ACCESSIBILITY COMPLIANCE REPORT

For DA Application

Project Address: Building 28 Western Sydney University
2 Bullecourt Ave, Milperra NSW

Report No: DA-24190

Att. 01 Floor Plans prepared by "Envision Group Pty Ltd" Issue No. 1 dated 11/12/2024

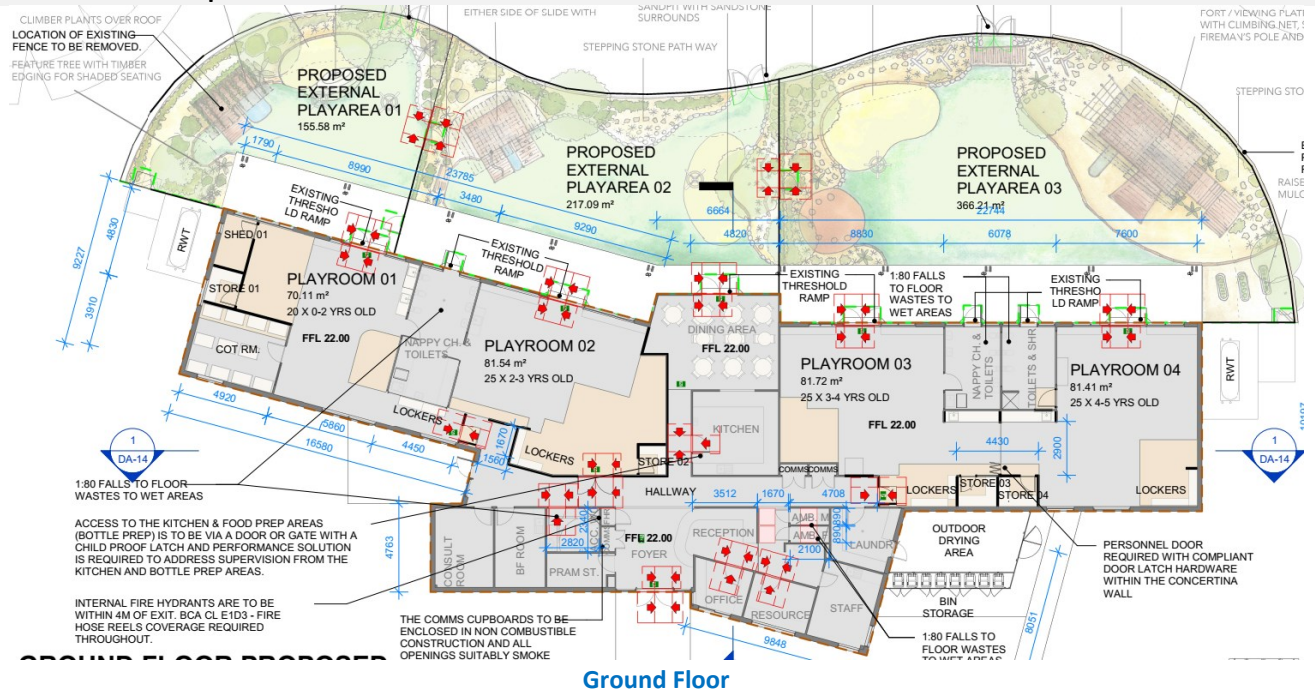
Notes: See Att. 01 – can be compliant at CC stage

Notes: See Att. 01 – can be compliant at CC stage

(c) Signage in accordance with AS 1428.1 must be provided for accessible unisex sanitary facilities to identify if the facility is suitable for left (LH) or right (RH) handed use. Reference: Figure 17 Notes: See Att. 01 – 1 'LH' accessible WC has been provided and can be compliant at CC stage	<input type="checkbox"/>	<input type="checkbox"/>	✓
